# knitter-switch

## Product-Change Notification

### Epoxy sealing of terminals

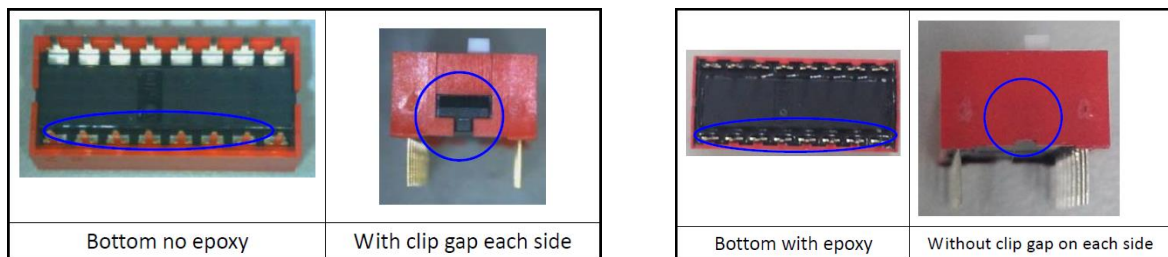
To improve safety against flux entry, the terminals will be sealed with epoxy from now on. Additionally the case is optimized to support the sealing safety.

The change of case allows to distinguish the non-sealed and the sealed version easily.
